ADDENDUM ONE

Southwest Allen County Schools - Whispering Meadows Elementary School
415 Mission Hill Drive
Fort Wayne, IN 46814

Commission No.: F24094
Addendum Date: 2025.11.21

R101

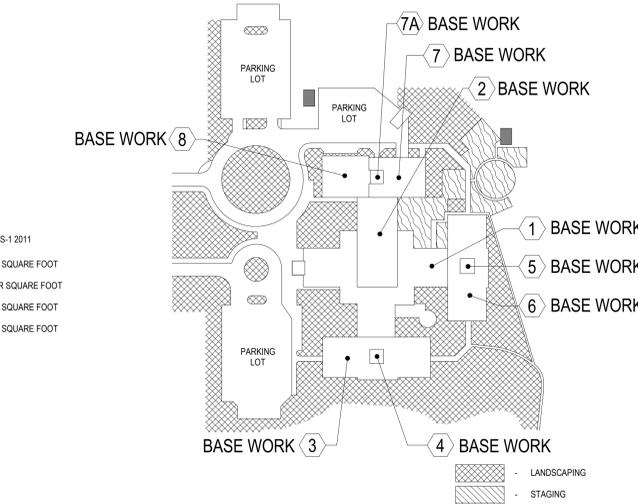
Sheet R101 - ROOF PLAN - Plan Work Description Notes Base Work - Note <2> **CHANGE TO READ** "REMOVE EXISTING (EXG) 4-PLY BUILT UP ROOFING (BUR) SYSTEM, ¾" FIBERGLASS INSULATION, FLASHINGS (FLGS), CANTS AND STRIPPINGS. EXISTING MECHANICALLY ATTACHED 4.25" POLYISOCYANURATE AND ALL TAPERED INSULATION KICKBACKS TO REMAIN, AREA <1>, <2>, <3>, <4>, <5>, <6>, <7>, <7A>, AND <8> - SEE EXISTING CONDITIONS 3/R101

Sheet R101 - ROOF PLAN - 3/R101 - Existing Conditon - INSULATION - **CHANGE TO READ** "(1) LAYER OF ¾" FIBERGLASS COVERBOARD ADHESIVELY ADHERED OVER (1) LAYER OF 4-1/4" POLYISOCYANURATE INSULATION MECHANICALLY ATTACHED

- NO WORK AND/OR MATERIALS TO BE STORED/PERFORMED IN THIS AREA.
- REMOVE EXISTING (EXG) 4-PLY BUILT-UP ROOFING (BUR) SYSTEM, 3/4" FIBERGLASS INSULATION, FLASHINGS (FLGS), CANTS AND STRIPPINGS, EXISTING MECHANICALLY ATTACHED 4-25' POLYISOCYANURATE AND ALL TAPERED INSULATION KICKBACKS TO REMAIN. AREA <1>, <2>, <3>, <4>, <5>, <6>, <7>, <7A>, <8>, <8>. - SEE EXISTING CONDITIONS 3R101.
